SUBJECT: Forwards addl info re expansion of spent fuel storage capacity, in response to NRC 810127 request.

H. B. ROBINSON STEAM ELECTRIC PLANT UNIT NO. 2  
DOCKET NO. 50-261  
LICENSE NO. DPR-23  
REQUEST FOR ADDITIONAL INFORMATION CONCERNING  
SPENT FUEL POOL EXPANSION

AUXILIARY SYSTEMS BRANCH  
H. B. ROBINSON SFP EXPANSION PRELIMINARY QUESTIONS

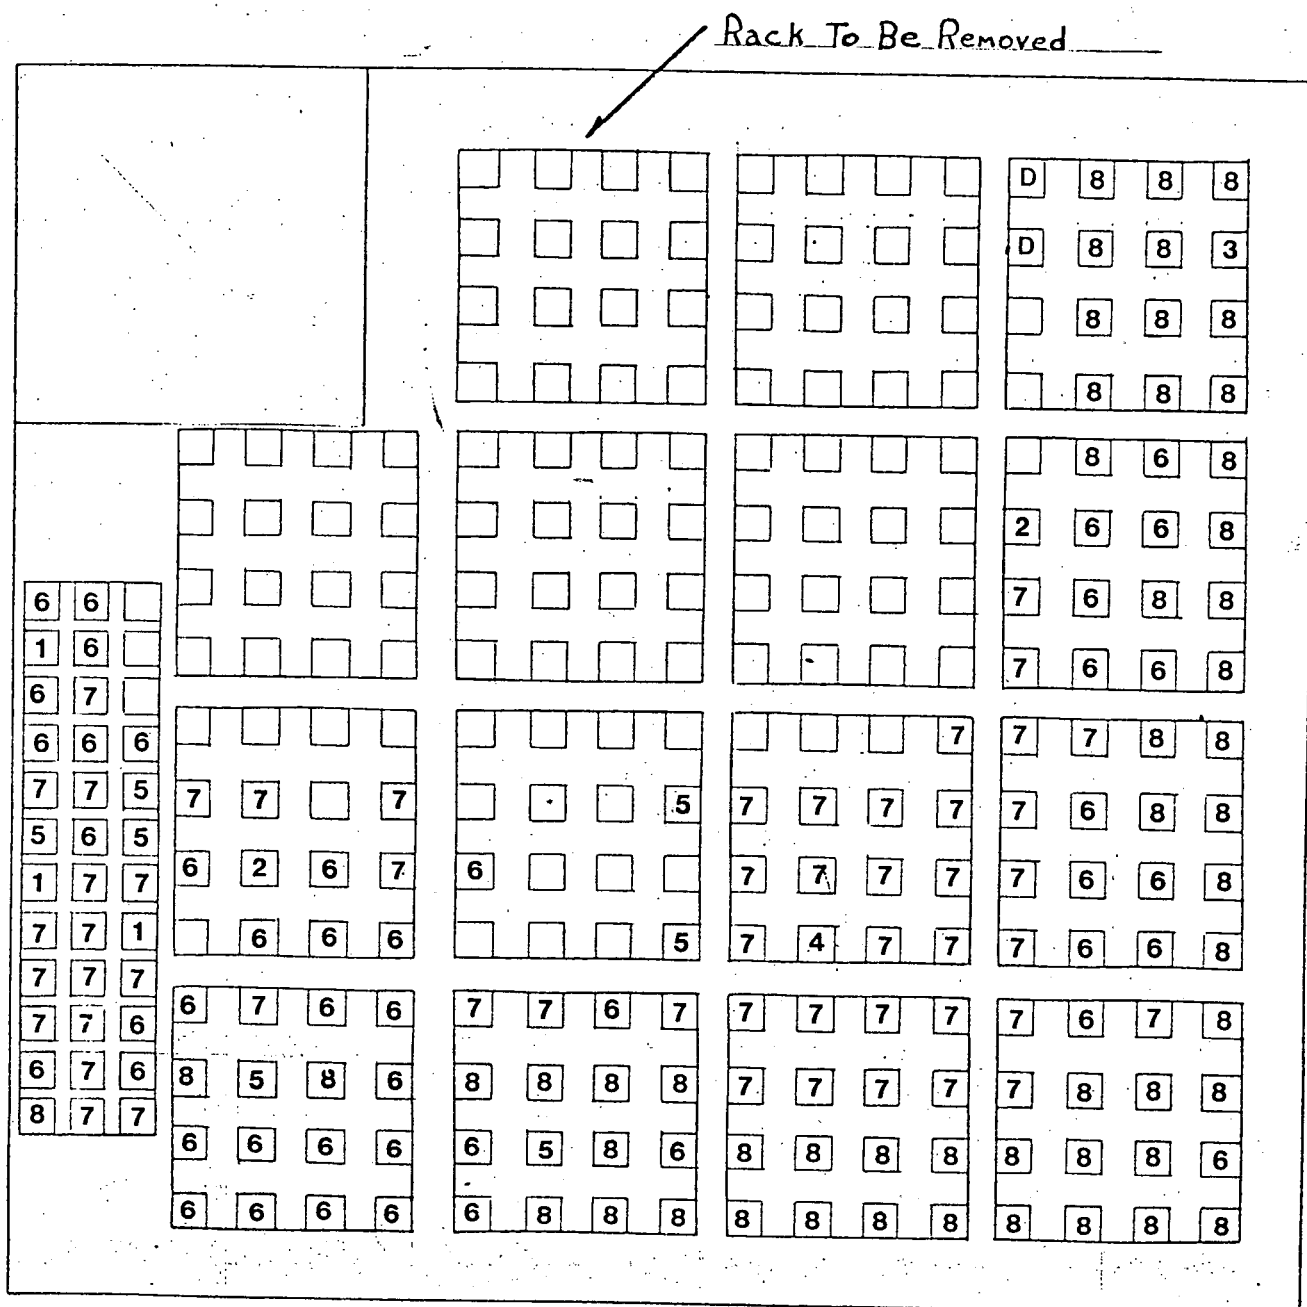
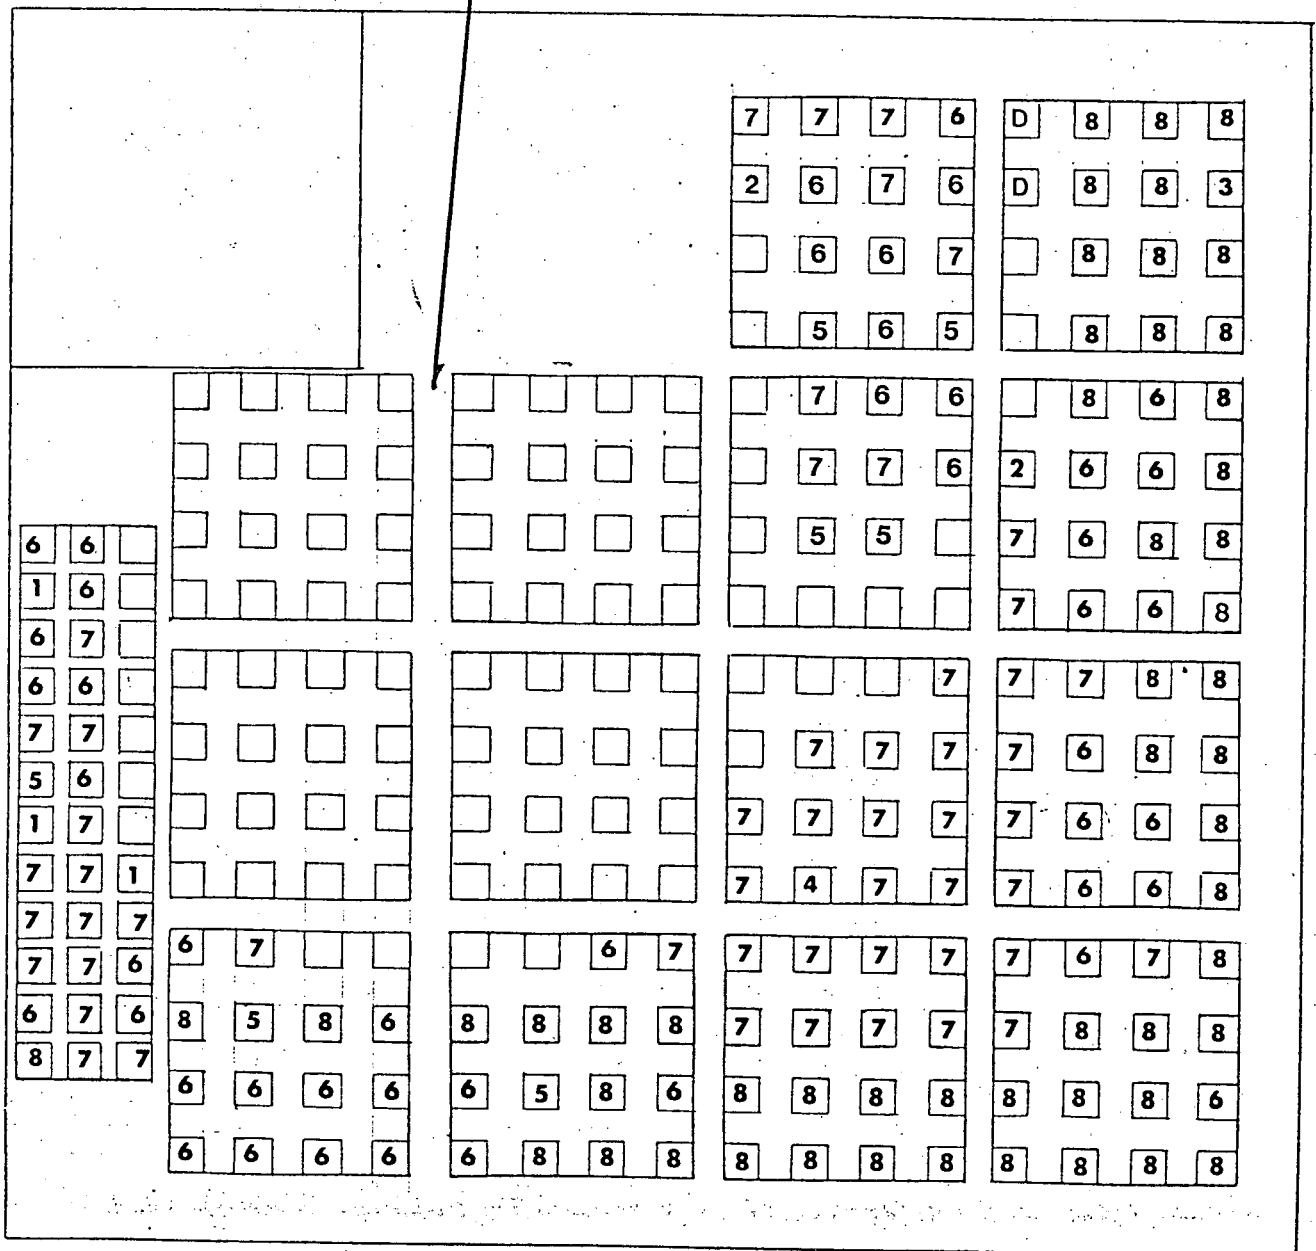
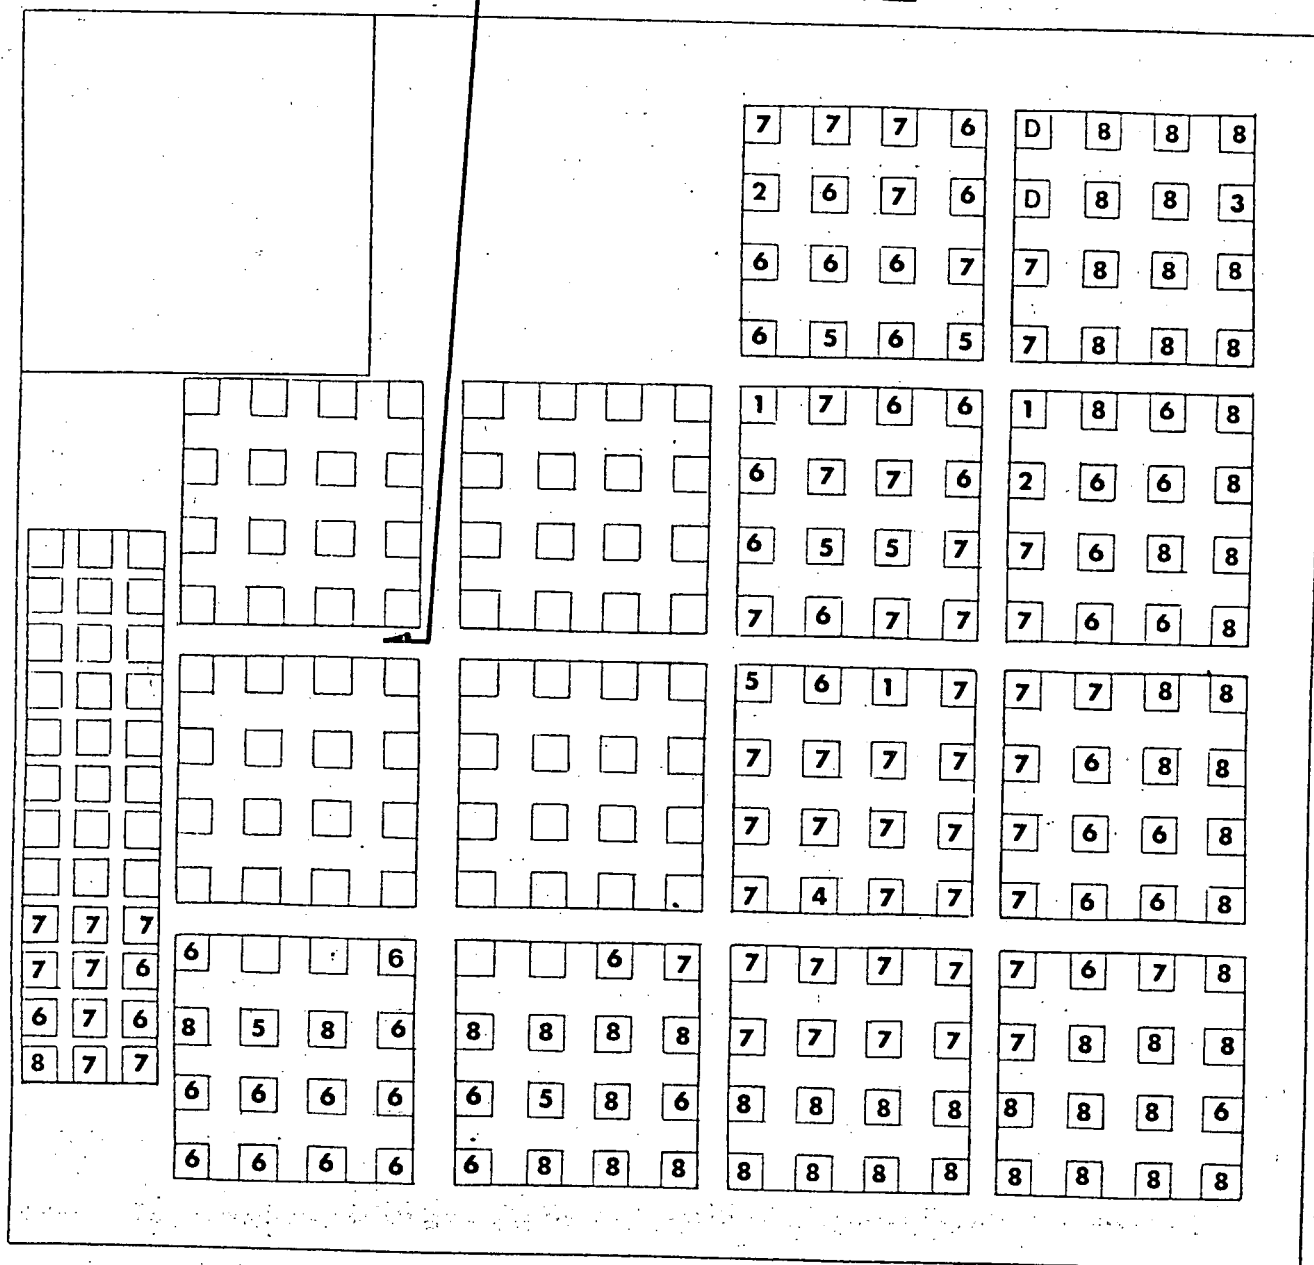
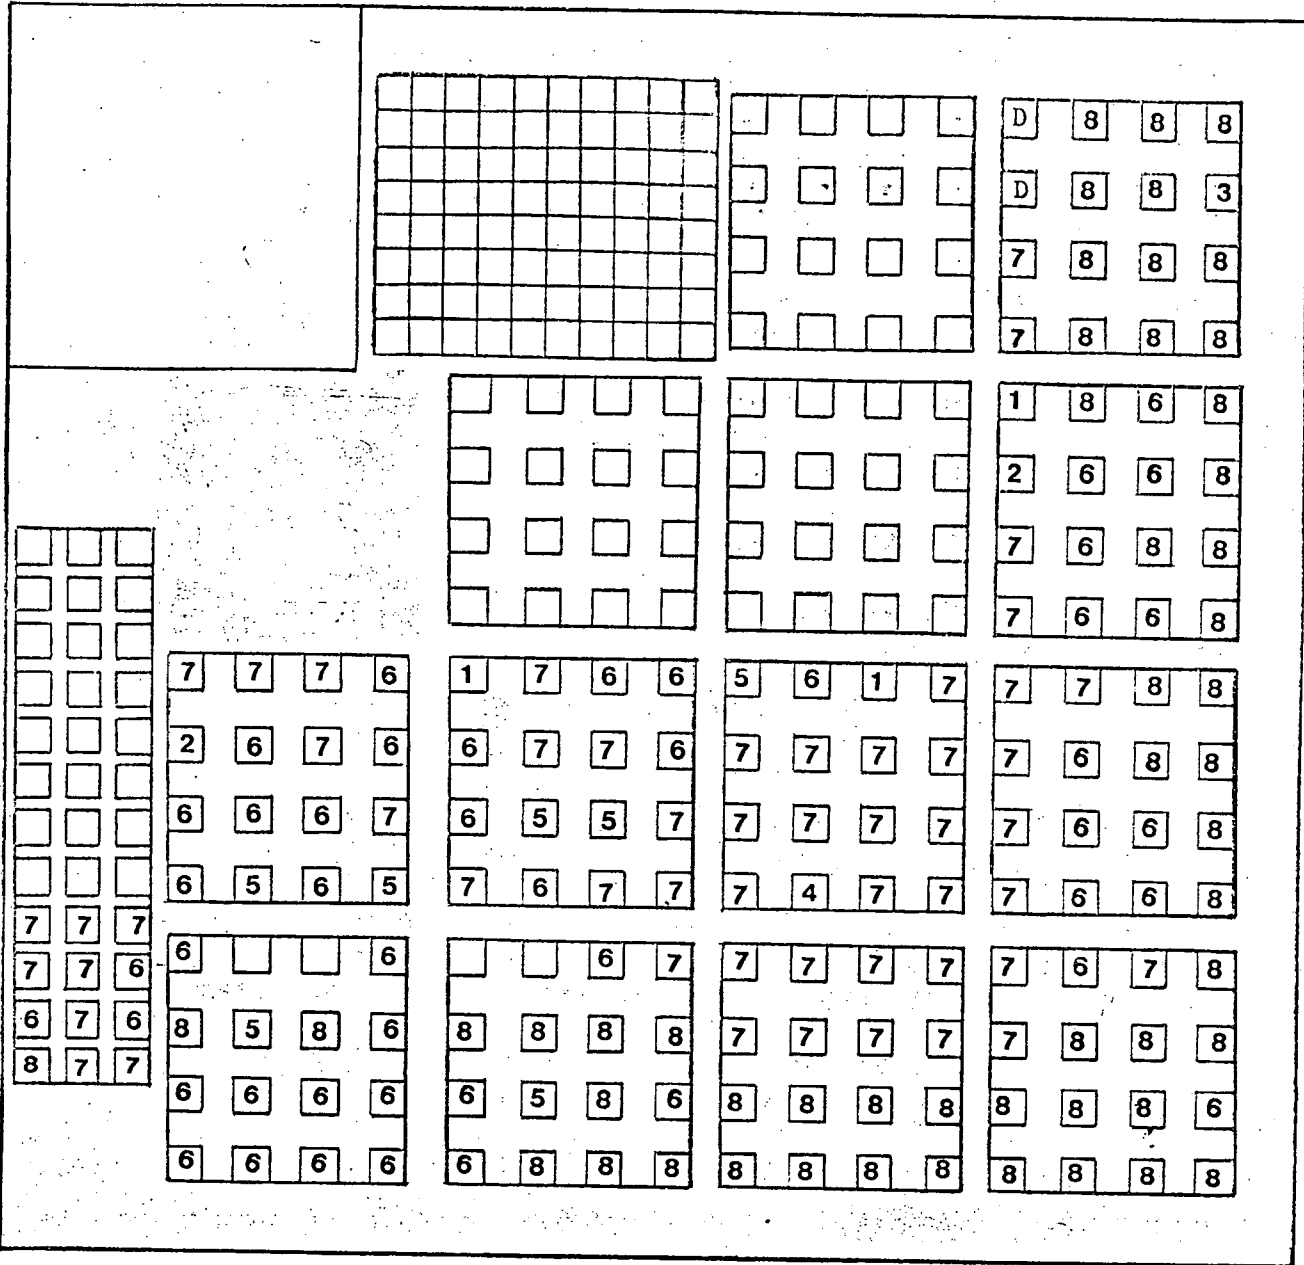
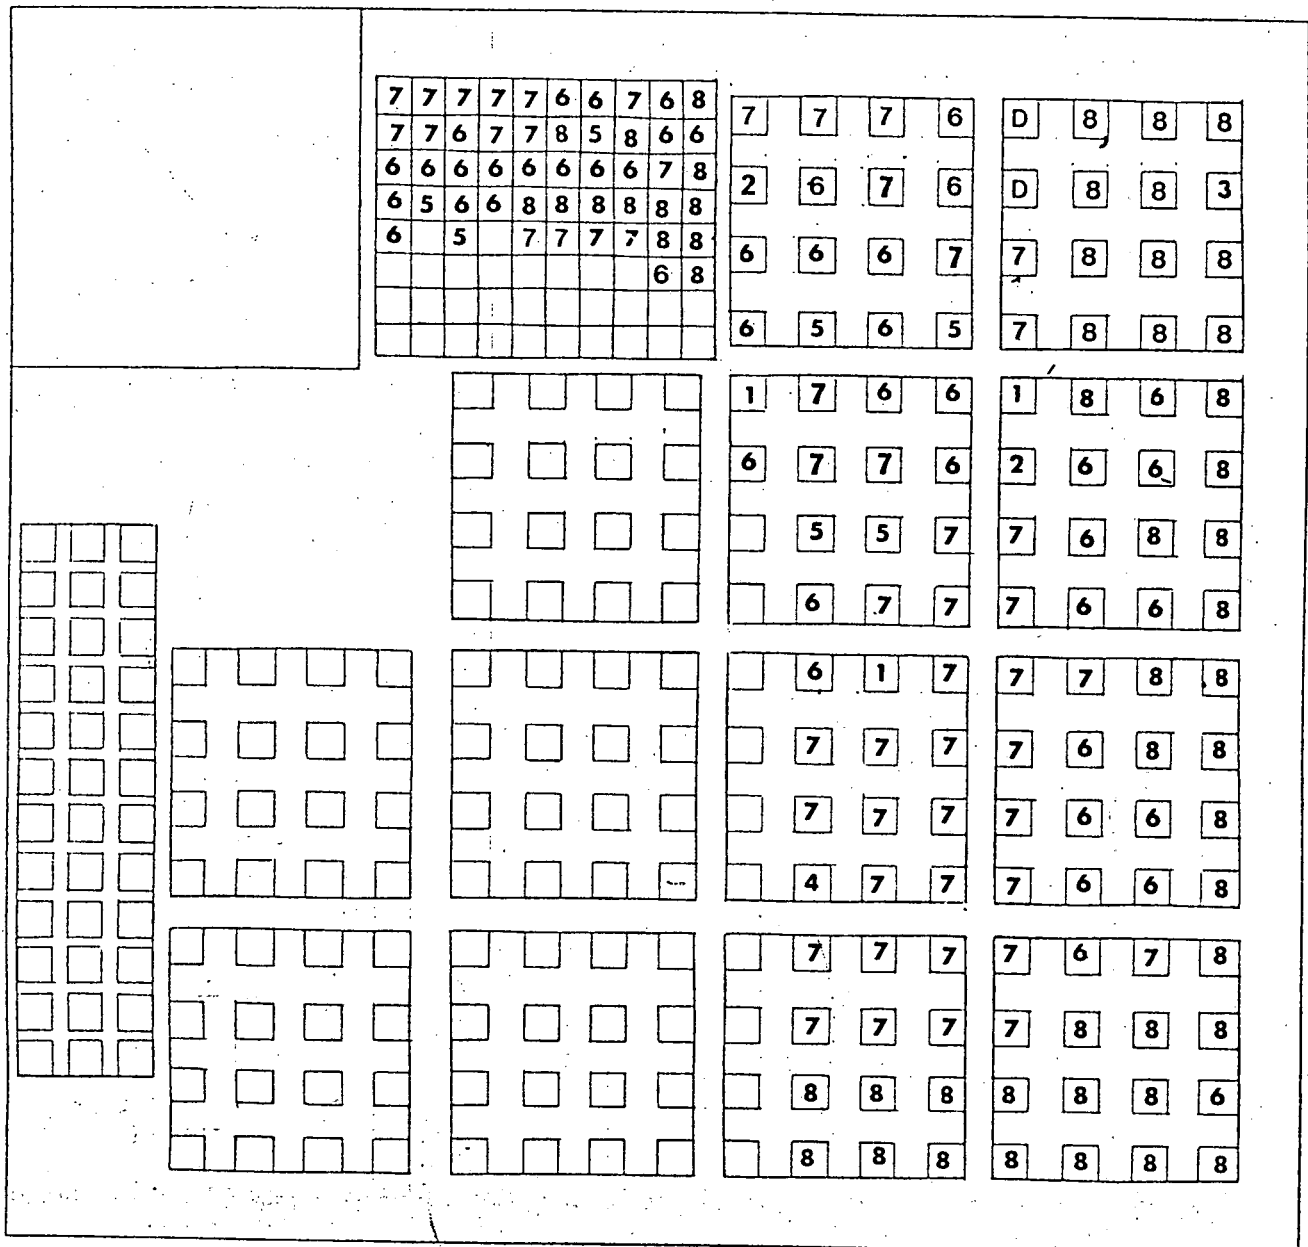
5. With the aid of drawings indicate the total number of fuel assemblies stored in the spent fuel storage pit as well as their location and decay times, in relation to the travel paths of the heavy load handling operations associated with the described modifications.

Figures A through G show the locations of the fuel assemblies stored in the spent fuel pool at present and after each fuel shuffle during rack installation. Fuel will be shuffled so as to keep the maximum possible distance between divers and spent fuel (approximately 9 to 10 feet). Therefore, spent fuel will not be in or near the work area or paths where racks are being removed or installed. No loads will pass over spent fuel locations. The discharge dates for the fuel assemblies identified in Figures A through G are as follows:

<u>Assembly Index</u>	<u>Discharge Date</u>
1	3-16-73
2	5-04-74
3	10-31-75
4	10-30-76
5	1-27-78
6	4-11-79
7	8-08-80
8	10-09-81 (projected)
